Access Compliance Report

Public Rights-of-Way

Intersection ID: 10037850	Main Street: SHARON_RD	Cross Street: N/A	Location: NE
ADA ID: BE25971A8D77	Ramp Type: Perp	Initial Pass/Fail: Fail	Overall Compliance: No
			Severity Score: 21.25

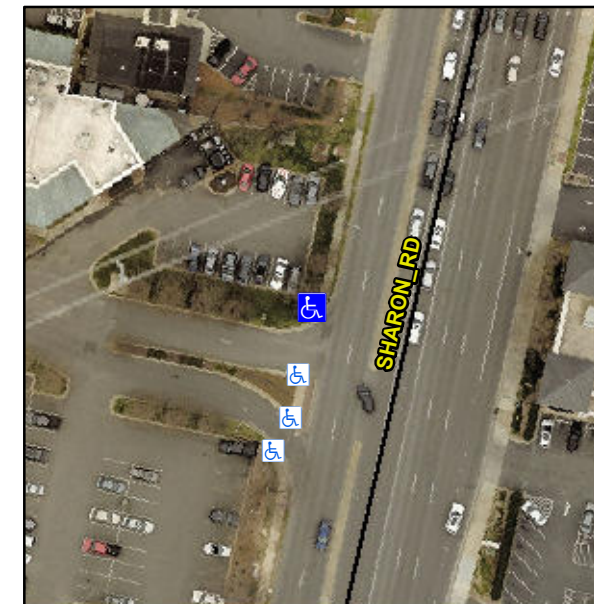
R304.5.1, R304.2.2

Compliance	Description	Data	Compliance	Description	Data
N/A	Ramp Length (in)	62.5	No	Ramp Slope (%)	9.8
No	Ramp Width (in)	46.0	Yes	Ramp XSlope (%)	0.7
N/A	Flare Type LT	N/A	N/A	Flare Type RT	N/A
N/A	Flare Slope LT (%)	N/A	N/A	Flare Slope RT (%)	N/A
N/A	Flare Traversable LT?	N/A	N/A	Flare Traversable RT?	N/A
N/A	Landing Length (in)	N/A	N/A	DWS Provided?	N/A
N/A	Landing Width (in)	N/A	N/A	DWS Contrast?	N/A
N/A	Landing Slope (%)	N/A	N/A	DWS Length (in)	N/A
N/A	Landing X Slope (%)	N/A	N/A	DWS Full Width?	N/A
N/A	Landing Curb? (Y/N)	N/A	N/A	DWS Offset (in)	N/A
N/A	Shared Landing?	N/A			
N/A	Gutter Ponding?	N/A	N/A	Gutter Slope (%)	N/A
N/A	Gutter Lip Ht (in)	N/A	N/A	Gutter X Slope (%)	N/A
N/A	Painted X Walk1?	No	N/A	Painted X Walk2?	N/A
	X Walk 1 Direction	To S		X Walk 2 Direction	N/A
N/A	X Walk 1 Width (in)	N/A	N/A	X Walk 2 Width (in)	N/A
	X Walk 1 Slope (%)	2.3		X Walk 2 Slope (%)	N/A
	X Walk 1 X Slope (%)	0.4		X Walk 2 X Slope (%)	N/A

Remove & Replace Entire Ramp.
